APPROVED
BY gpc DATE 9/7/17
FOR 21007 Retaining Wall
NOTES Change

EL PASO COUNTY
PLANNING AND COMMUNITY DEVELOPMENT

Mimi Crough
11280 Calle Carvo
TAX ID # 761100202
Red Rock Valley Est
Lot 23 Block 5
ADD 17554
Plot 2369
A-5
House Footprint

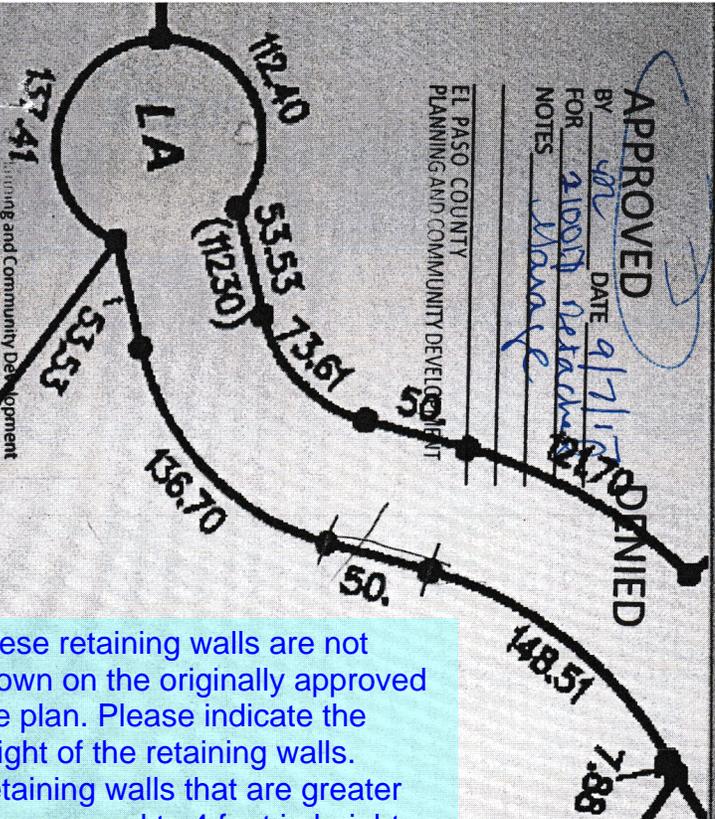
These retaining walls are not shown on the originally approved site plan. Please indicate the height of the retaining walls. Retaining walls that are greater than or equal to 4 feet in height require a design by a professional engineer and building permit from Regional Building Department.

PLAT #2369

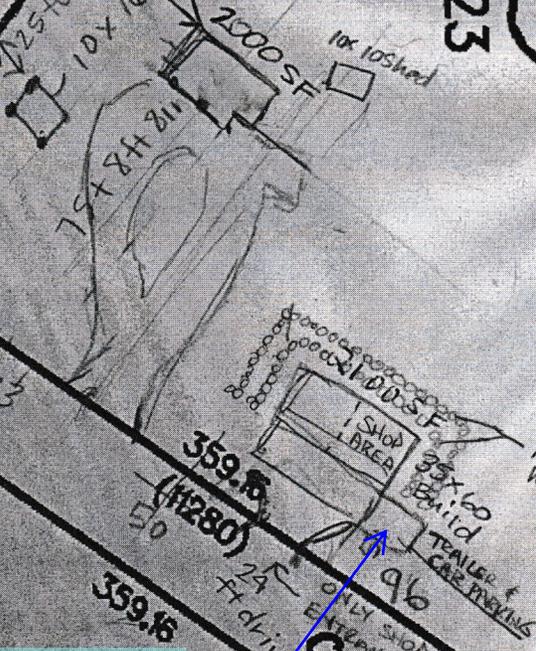
Please provide dimensions for the proposed parking area shown.
